Road Safety Audit Review

Town:	Weathersfield	Date Reviewed:	October 5, 2016
Route:	VT 131, US 5 and VT 12	Mile points:	VT 131: 8.28-8.60 US 5: 5.12, VT 12: 0.39

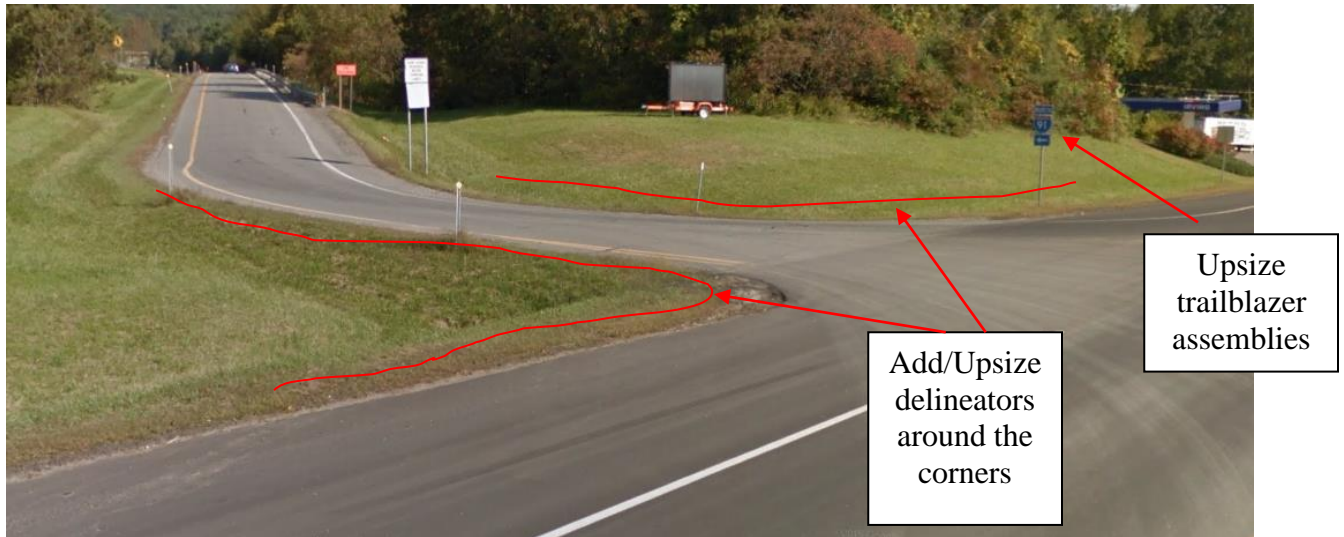
Concern: Visibility of I-91 NB on Ramp

There have been issues reported concerning the visibility of the I-91 northbound on ramp and not being able to determine where to make the turn when it was foggy or during nighttime. This is an issue that has been mostly affecting eastbound motorists on VT 30.

Safety Enhancements:

Install 6" x 8" delineators around the two corners of the intersection.

Upsize the I-91 trailblazer assemblies that are located at the ramp to improve detection by turning motorists. Upsize both assemblies for both directions.
